ADDENDUM 1

PROJECT NAME: Churchill Ave Area Drainage Improvements

DATE: 11/01/2023

PROJECT NO: 23-03797

SHEET 47 OF 56

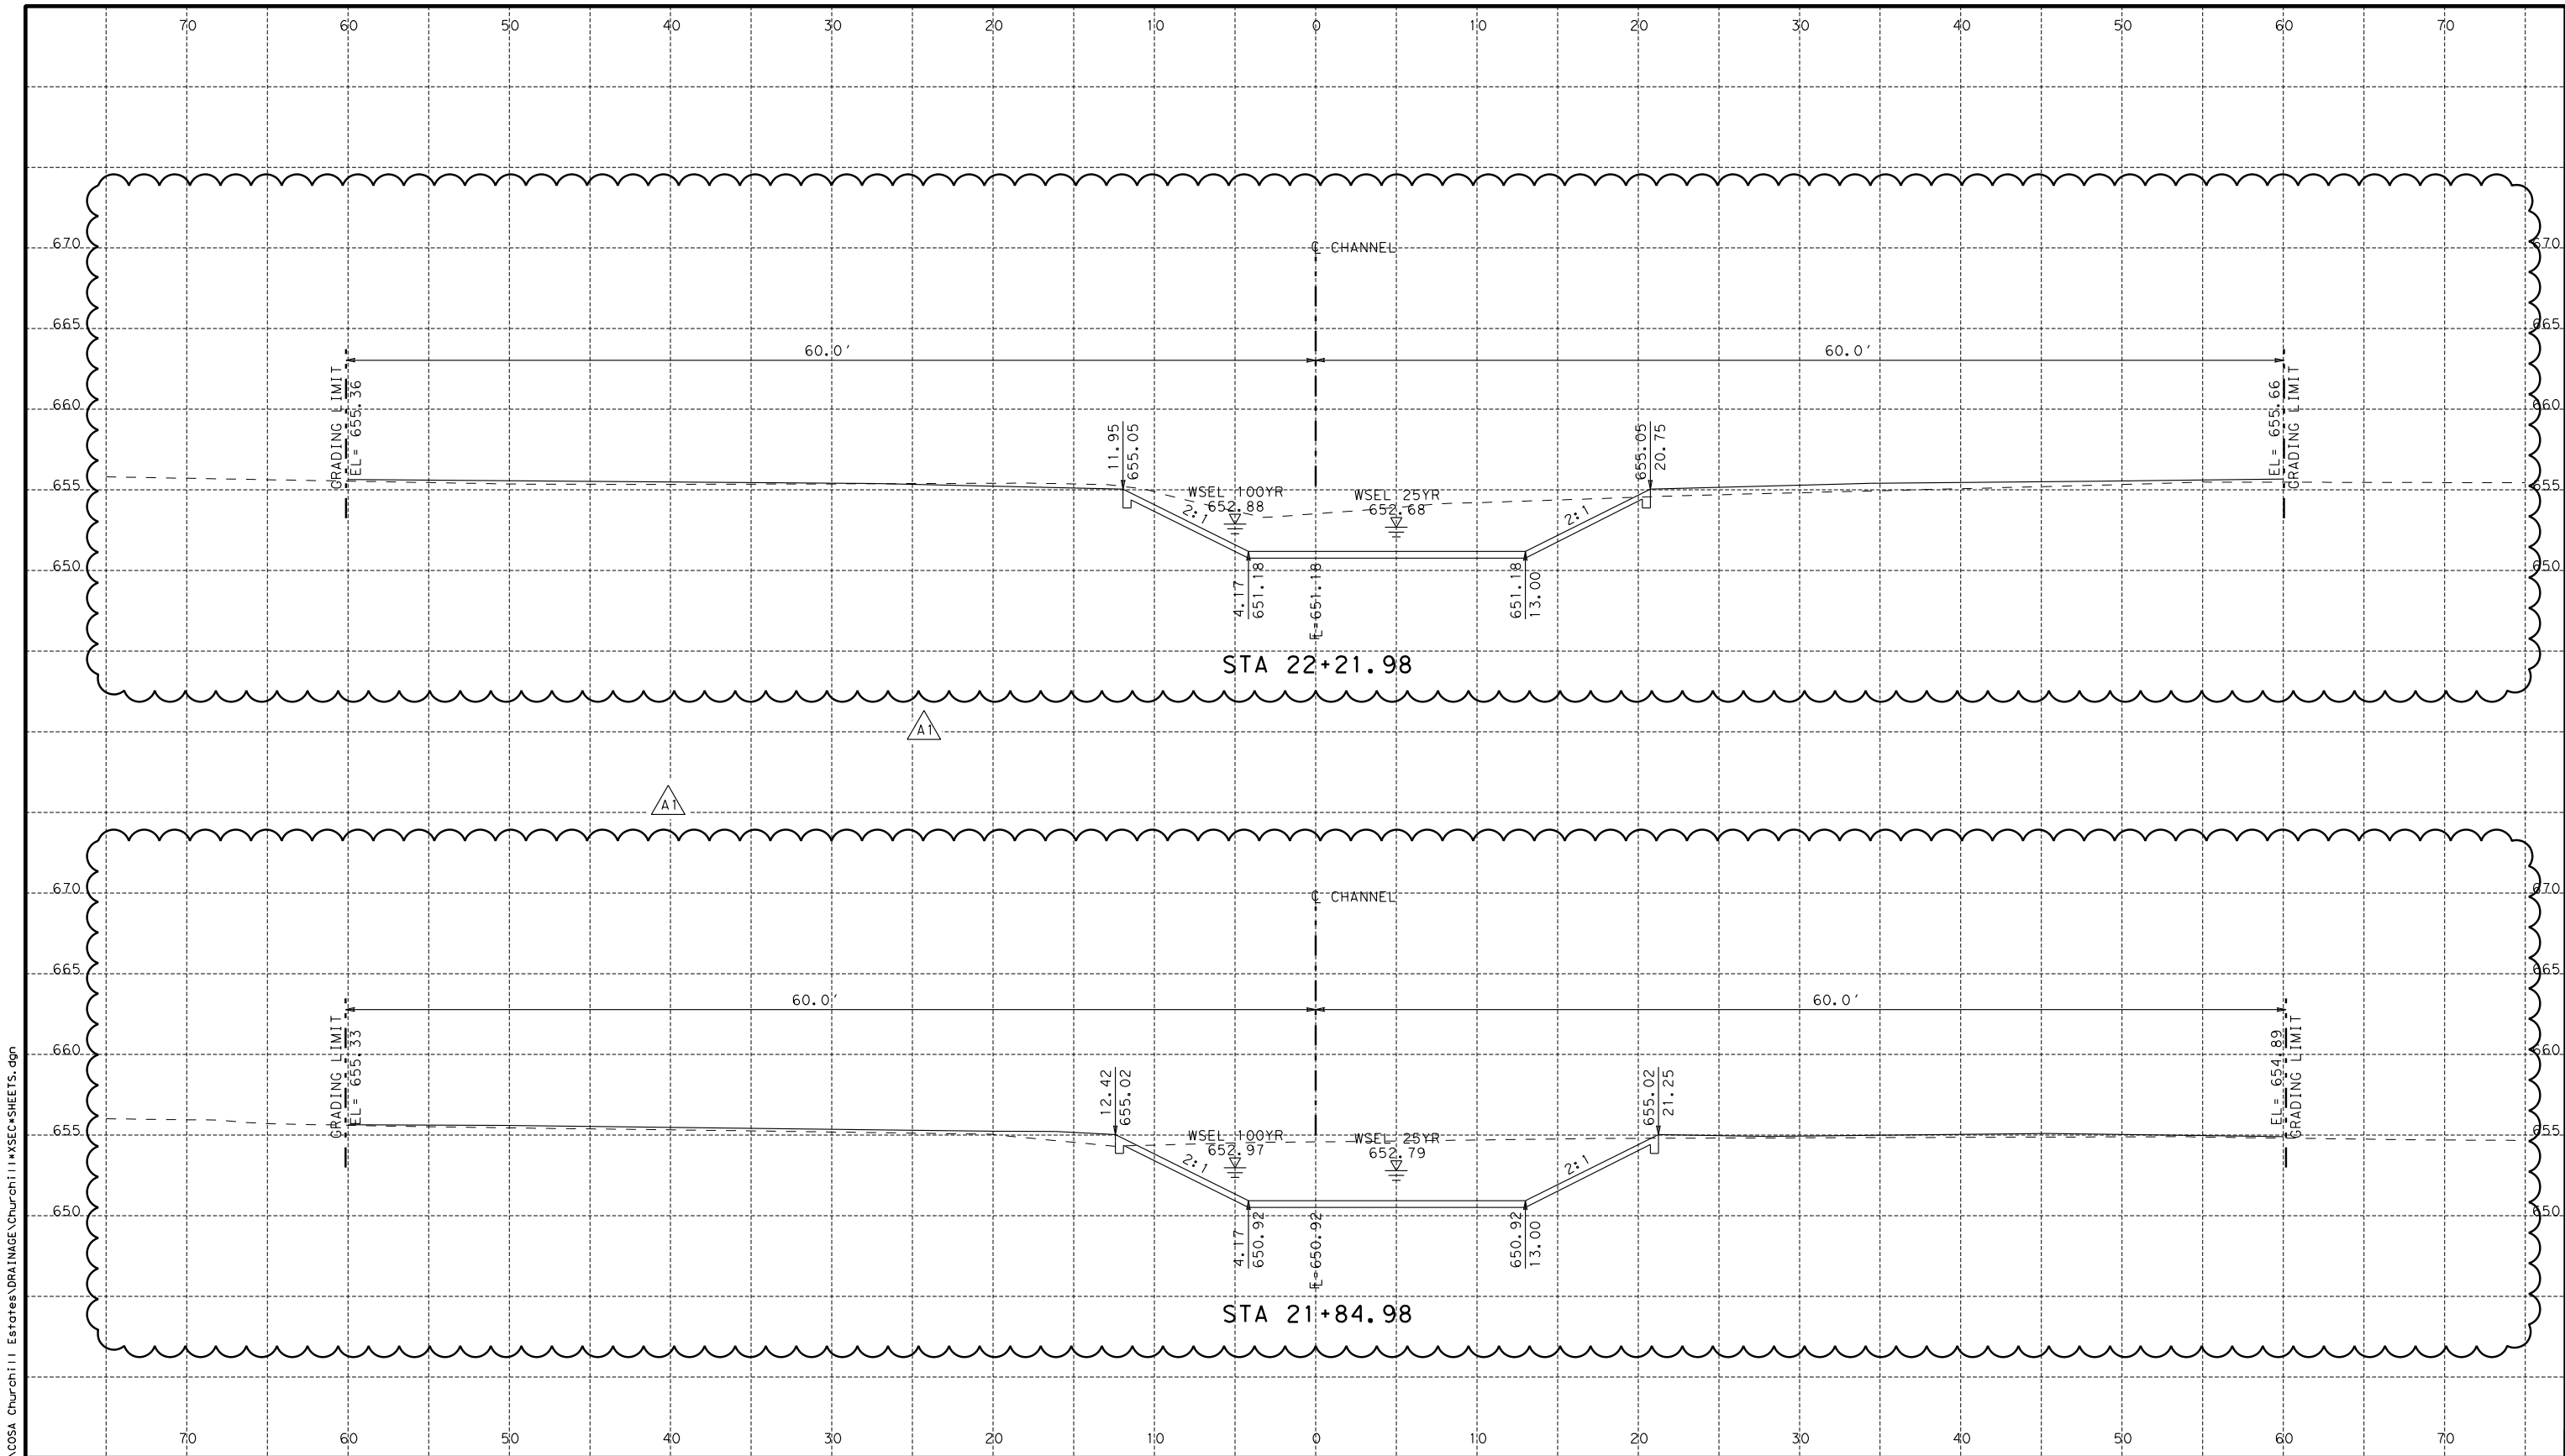
1. Revised Plan Sheet 79 – Cross Sections – Revised grading and riprap tie in elevations callouts to match details.
2. Revised Plan Sheet 96 – Cross Sections – Revised grading and riprap tie in elevations callouts to match details.
3. Revised Plan Sheet 97 – Cross Sections – Revised grading and riprap tie in elevations callouts to match details.
4. Revised Plan Sheet 98 – Cross Sections – Revised grading and riprap tie in elevations callouts to match details.
5. Revised Plan Sheet 112 – Drainage Details – Updated riprap elevation.

3. Question: Cross sections @ station 21+80.00 to 22.21.98 grading elevation at left side does not match at end of ROW. Please clarify.

Response: Cross section plan sheets 96-98 have been updated to reflect the correct tie in elevations to match the riprap details and grading layouts.

REVISIONS		
DATE	NO.	DESCRIPTION
OCT '23	A1	REVISED TIE-IN ELEVATIONS
